In the Matter of	)	
	)	
Service Rules for Advanced Wireless Services in the 2155-2175 MHz Band	)	**WT Docket No. 07-195**
	)	
	)	
Service Rules for Advanced Wireless Services in the 1915-1920 MHz, 1995-2000 MHz, 2020-2025 MHz and 2175-2180 MHz Bands	)	**WT Docket No. 04-356**
	)	
	)

Comments from the DECT Forum on the Further Notice of Proposed Rulemaking specifically related to Revision of the Rules that may Impact the UPCS Band

Figure 1 - Capacity as function of the UPCS upper threshold limit.
Free space model of 120 system access channels

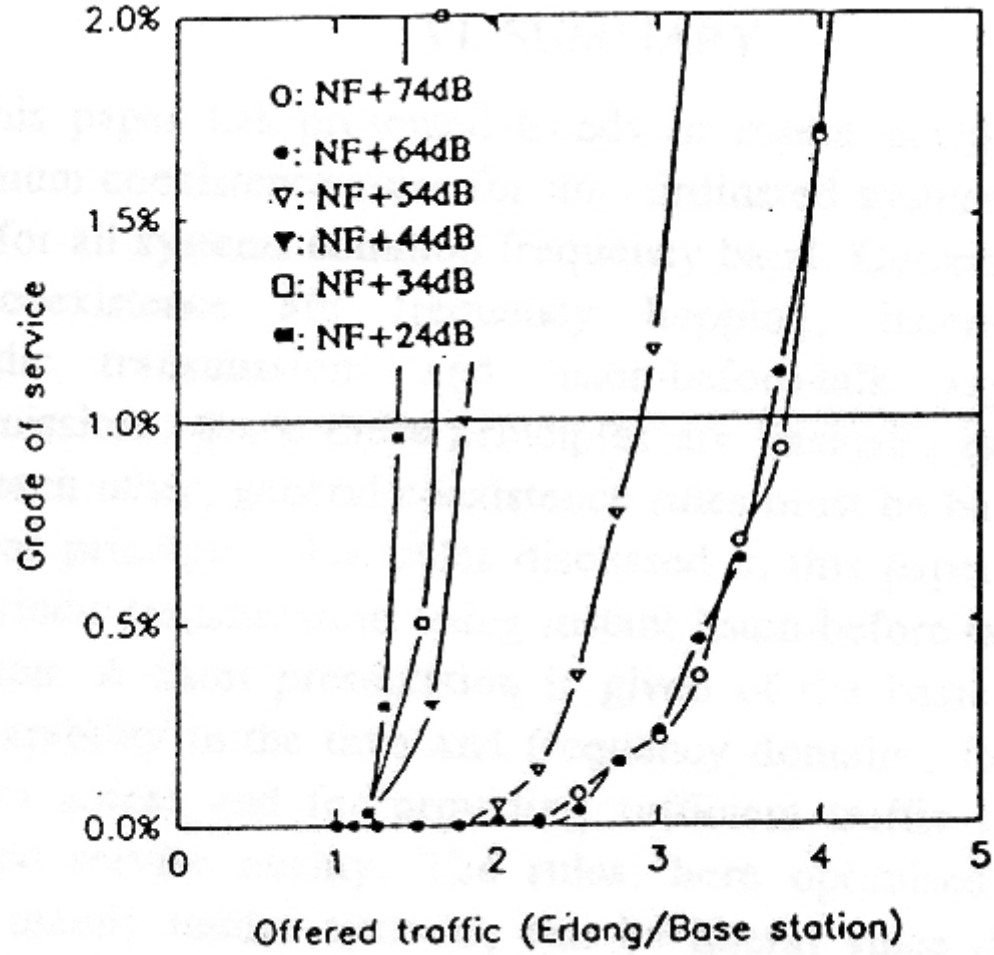
Figure 1 shows that for this specific simulation, the capacity (1 % grade of service limit) the system capacity would increase by at least 60% if the upper threshold is changed from TN + 50 dB to TN + 65 dB.

For the UPCS band only 10 MHz and 60 access channels are available. In this case it is even more important that an appropriate “upper threshold” be used. If the “upper threshold” is too low it will restrict use of channels that are perfectly useful for communication. In dense usage environments there would be a loss of range. However,

Thus, having an upper threshold of "thermal noise floor + 65 dBm" would considerably increase the utilization (+60 %) of the UPCS band and decrease infrastructure costs for high capacity installations.

Figure D.1—Capacity as a function of the monitoring threshold limit (free space model of 120-system access channels)

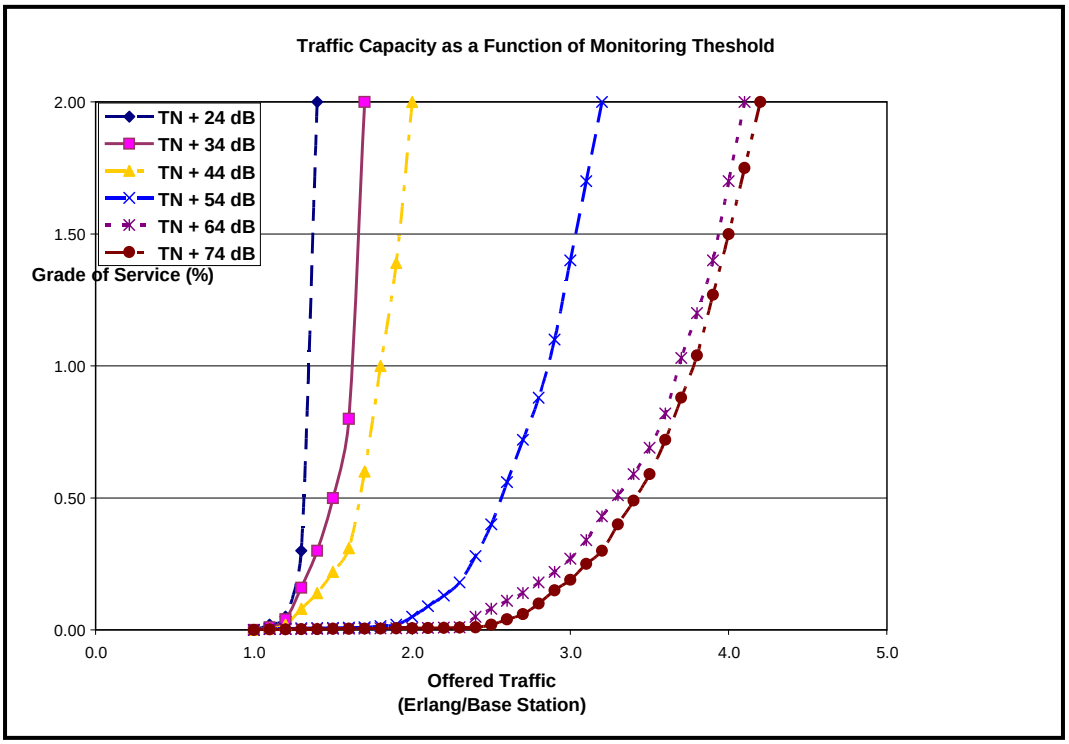
Figure D.1 shows that for this specific simulation, the system capacity (1% grade of service limit) would increase by at least 60% if the monitoring threshold is changed from TN + 50 dB to TN + 65 dB.

For cases where access channels are relatively limited, it is even more important that an appropriate monitoring threshold be used. In such scenarios, devices have relatively few channels to which they can escape. In the example cited, the device has 5 frequencies available and 60 access channels. If the monitoring threshold is too low, it will restrict use of channels that are perfectly useful for communication. In dense usage environments, there would be a loss of range. However, range in such environments is not the critical component and is typically compensated for by providing additional base stations to service the area.

Thus, having an upper threshold of “thermal noise floor + 65 dBm” would considerably increase the utilization (+60 %) and decrease infrastructure costs for high-capacity installations.
